**ADDENDUM NO. 1
TENDER NO. 166-18
DIESEL & MCC UPGRADES AT LOU ROMANO WATER RECLAMATION PLANT**

October 11, 2018

CITY OF WINDSOR
LOU ROMANO WRP DIESEL AND MCC UPGRADES

PROJECT NO. 15-2463
SHEET NO. **E12**

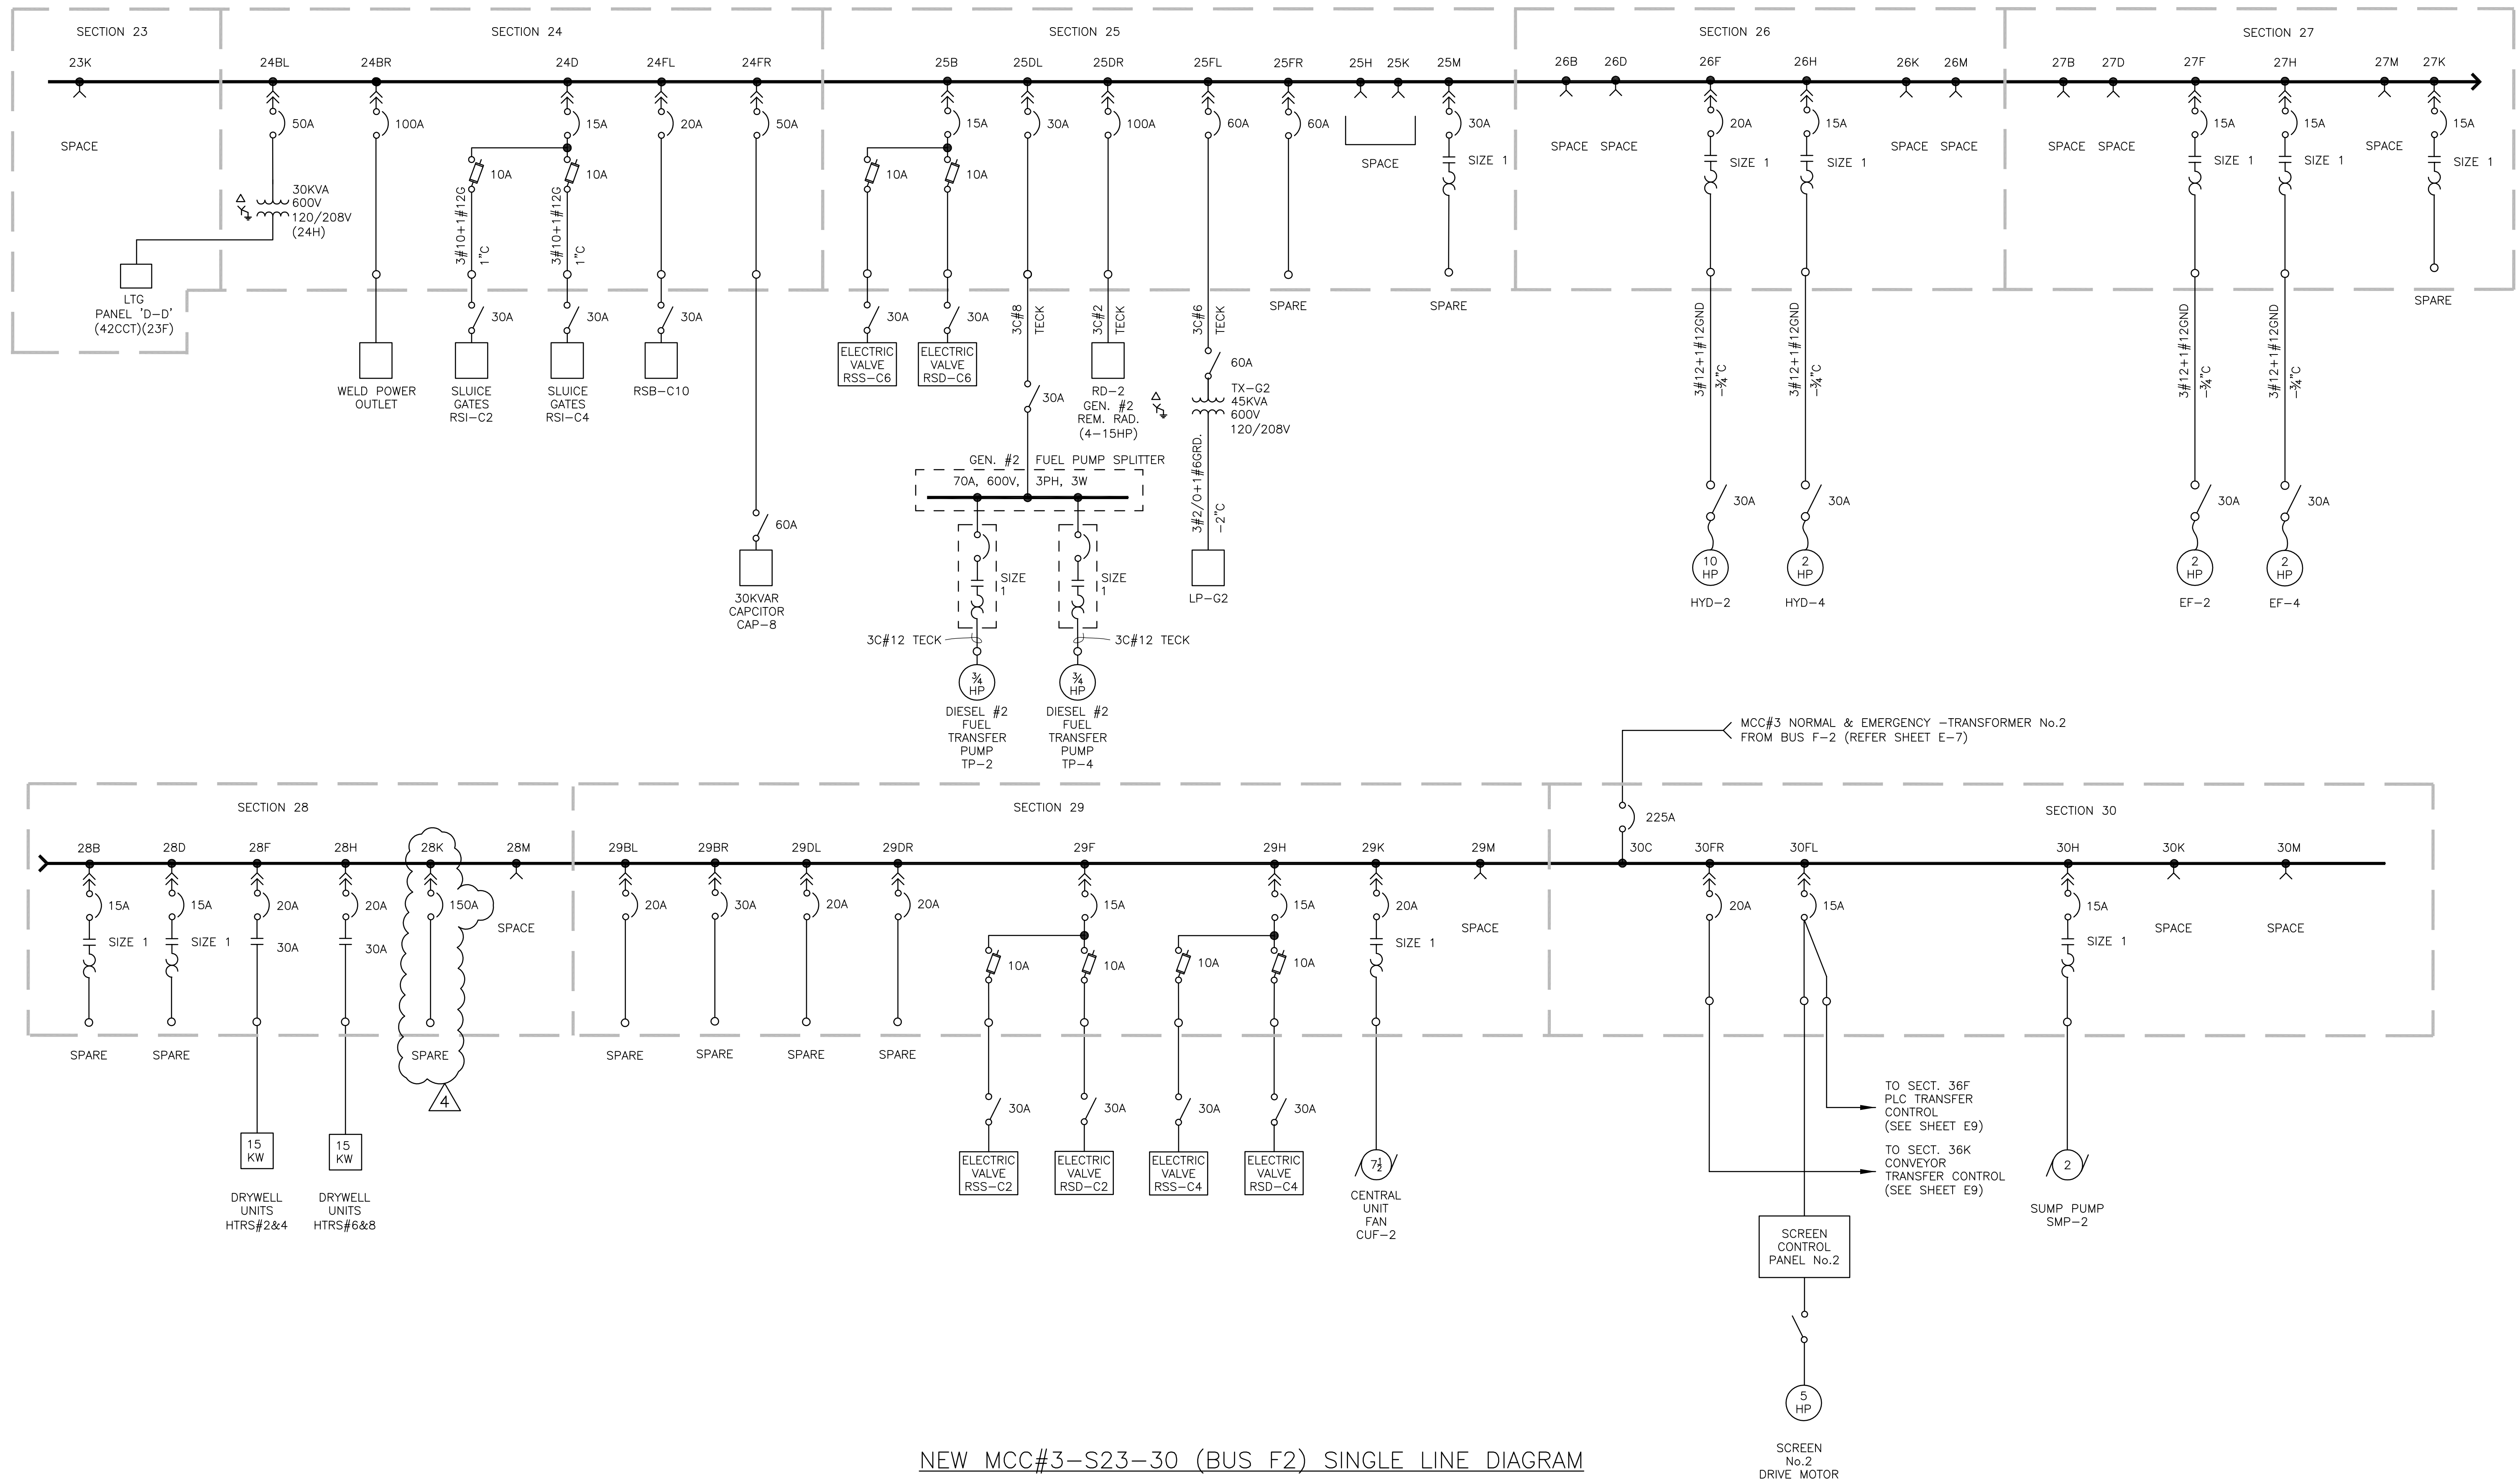
Refer to Electrical Drawings E8 Rev 4 and E12 Rev 4 (attached)

Add 150A breaker for future drainage pumping system (by others).
